REVISED RESPONSE TO REQUEST FOR ADDITIONAL INFORMATION

APR1400 Design Certification

Docket No. 52-046

RAI No.: 274-8277
SRP Section: 07.01 - Instrumentation and Controls - Introduction
Application Section: Section 7.1, 7.3, and 10.2
Date of RAI Issue: 10/27/2015

Figure 7.3-23 Radiation Monitoring System Measurement Channel Functional Diagram

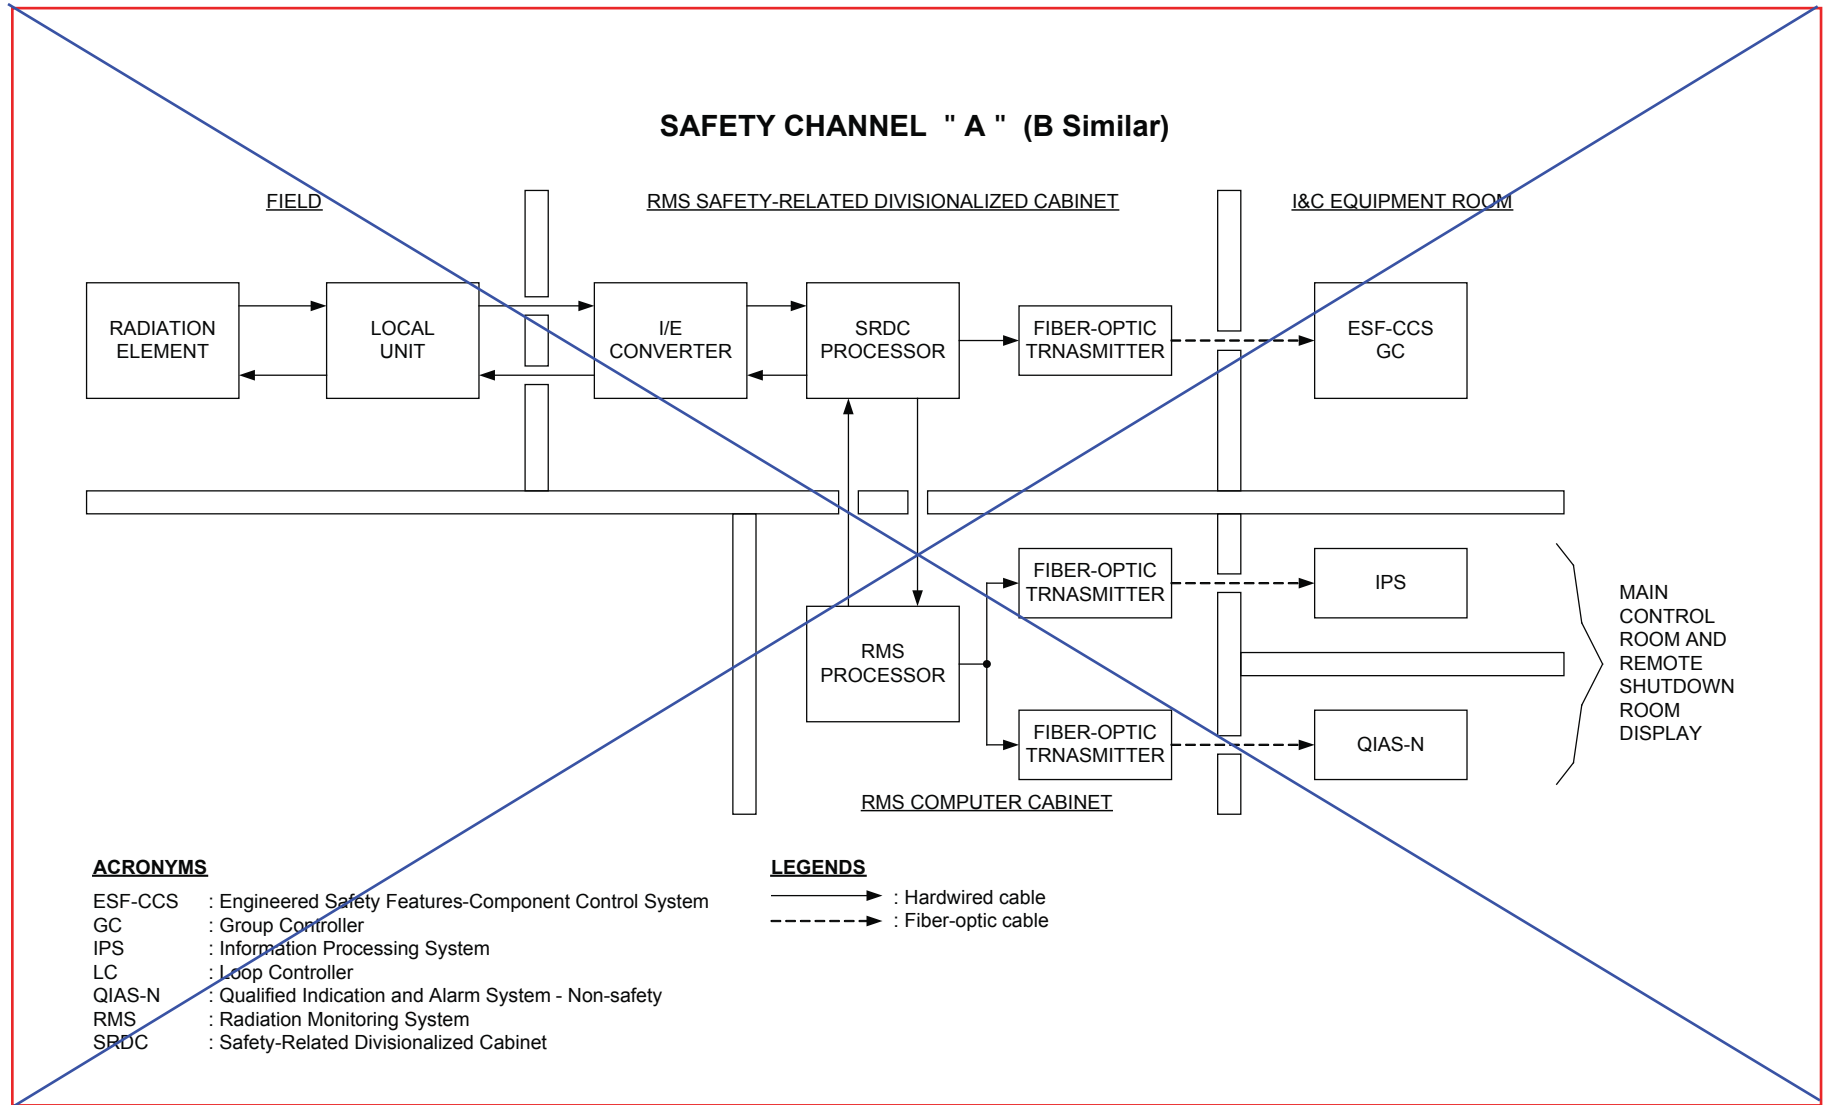
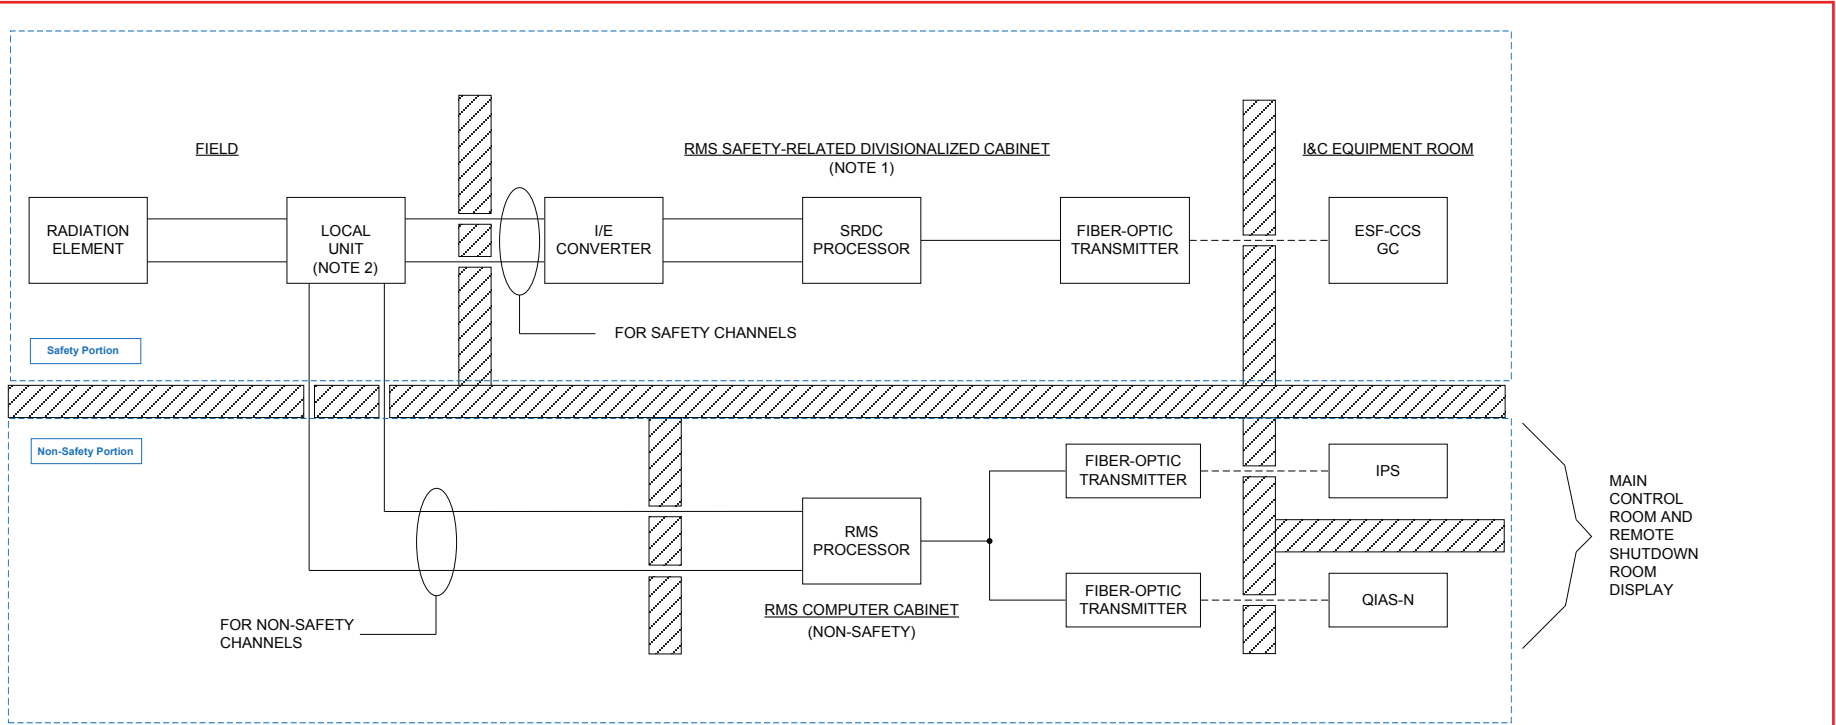
- a. APR1400 FSAR Tier 2, Section 7.3.1.1, states the balance of plant (BOP) ESFAS receives process variable signals from the safety portion of the RMS, manual ESF system-level actuation switches, and manual channel bypass switches. The BOP ESFAS consists of 1-out-of-2 logic taken twice except for the Fuel handling area emergency ventilation actuation signal (FHEVAS), which has one 1-out-of-2 logic. APR1400 FSAR Tier 2, Figure 7.3-23, shows the RMS measurement channel functional diagram, but design descriptions or reference to this figure were not provided in FSAR Tier 2, Section 7.3. Based on this figure, it is not clear how many divisions are in the RMS SRDC. In addition, it is not clear whether the RMS computer cabinet is safety-related or non-safety. If the RMS processor in the computer cabinet is non-safety, then how is it isolated from the SRDC processor to meet the independence requirements of IEEE Std. 603-1991, Clause 5.6.3? If the RMS processor is safety-related, how is it meeting independence requirements of IEEE Std. 603-1991, Clause 5.6.3 when transmitting information to the IPS and QIAS-N?

- a. DCD Tier 2, Section 7.3.1.1 will be revised to provide a detailed design description and reference to Figure 7.3-23.

Figure 7.3-23 is to be revised to reflect the latest system functional configuration. The radiation monitoring system (RMS) processor receives the electrically isolated radioactivity measurement signal directly from the local unit, rather than from the safety related divisionalized cabinet (SRDC) processor.

The revised figure is a simplified block diagram which provides a functional overview of the RMS. Although the number of divisions for the SRDC can be inferred from the previous heading written above the SRDC, where it states "safety channel 'A' (B similar)," a note has been added to clearly state the SRDC cabinet has redundant

The RMS computer cabinet is non-safety related; Figure 7.3-23 is to be revised accordingly for clarity. Those measurement signals originating from the safety related detector channels that are transmitted to the non-safety RMS processor are electrically isolated using an IEEE Std 384 Class 1E qualified isolator per Clause 6.2.2, at each local unit. This satisfies the independence requirement between safety systems and other systems per IEEE Std 603-1991, Clause 5.6.3.

Since the isolation is done at the local unit, no isolation is needed for those signals sent to the IPS and QIAS-N. The revision to Figure 7.3-23 shows the connection from the RMS processor to the IPS and QIAS-N through a fiber-optic converter. The fiber-optic converter does not provide isolation, but provides data communication paths via fiber-optic signal transmission.

Replace this figure with attached figure A.
